Access Compliance Report

Public Rights-of-Way

(Curb Ramps)

Intersection ID: 2766	Main Street: CARDINAL_POINT_RD	Cross Street: JADE_TREE_LN	Location: W
ADA ID: 6C60D9AA3A6F	Ramp Type: BlendTrans2	Initial Pass/Fail: Fail	Overall Compliance: No
		Severity Score: 1.25

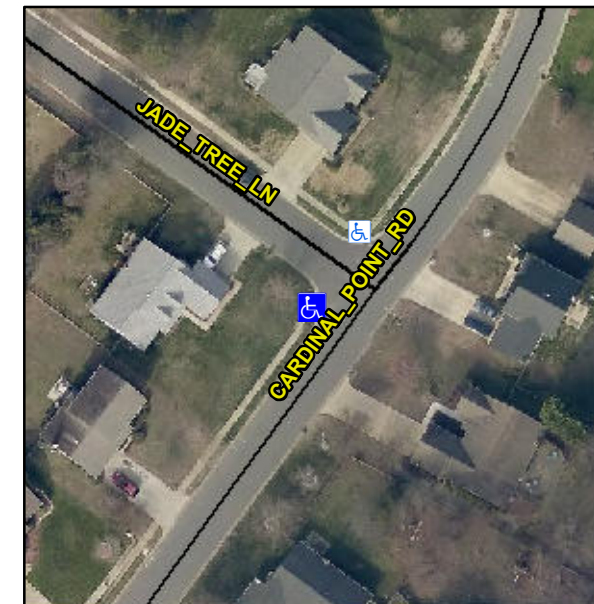
Not Found, R304.5.3

Compliance	Description	Data	Compliance	Description	Data
N/A	Ramp Length (in)	36.0	Yes	BlendTrans Slope (%)	3.5
Yes	Ramp Width (in)	48.0	No	BlendTrans XSlope (%)	2.1
N/A	Flare Type LT	N/A	N/A	Flare Type RT	N/A
N/A	Flare Slope LT (%)	N/A	N/A	Flare Slope RT (%)	N/A
N/A	Flare Traversable LT?	N/A	N/A	Flare Traversable RT?	N/A
N/A	Landing Length (in)	N/A	N/A	DWS Provided?	N/A
N/A	Landing Width (in)	N/A	N/A	DWS Contrast?	N/A
N/A	Landing Slope (%)	N/A	N/A	DWS Length (in)	N/A
N/A	Landing X Slope (%)	N/A	N/A	DWS Full Width?	N/A
N/A	Landing Curb? (Y/N)	N/A	N/A	DWS Offset (in)	N/A
N/A	Shared Landing?	N/A			
N/A	Gutter Ponding?	N/A	N/A	Gutter Slope (%)	N/A
N/A	Gutter Lip Ht (in)	N/A	N/A	Gutter X Slope (%)	N/A
N/A	Painted X Walk1?	No	N/A	Painted X Walk2?	N/A
	X Walk 1 Direction	To NE		X Walk 2 Direction	N/A
	X Walk 1 Width (in)	N/A		X Walk 2 Width (in)	N/A
	X Walk 1 Slope (%)	0.2		X Walk 2 Slope (%)	N/A
	X Walk 1 X Slope (%)	1.3		X Walk 2 X Slope (%)	N/A

N/A	Ramp inside XWalk1?	N/A	N/A	Ramp inside XWalk2?	N/A
	Road Slope (%)	1.3		Clear Space?	N/A
	Road X Slope (%)	0.2	N/A	Clear Space to XWalk (in)	N/A
N/A	Any Obstructions?	N/A	N/A	Storm Grate/Utility Hazard?	N/A
	Obstruction Type			Storm Grate/Utility Type	
		N/A			N/A
			Yes	Surface Condition? (G/P)	Good
			No	Curb Slope (%)	28.8

Remove & Replace Curb Ramp With Two New Directional Ramps or Equivalent.
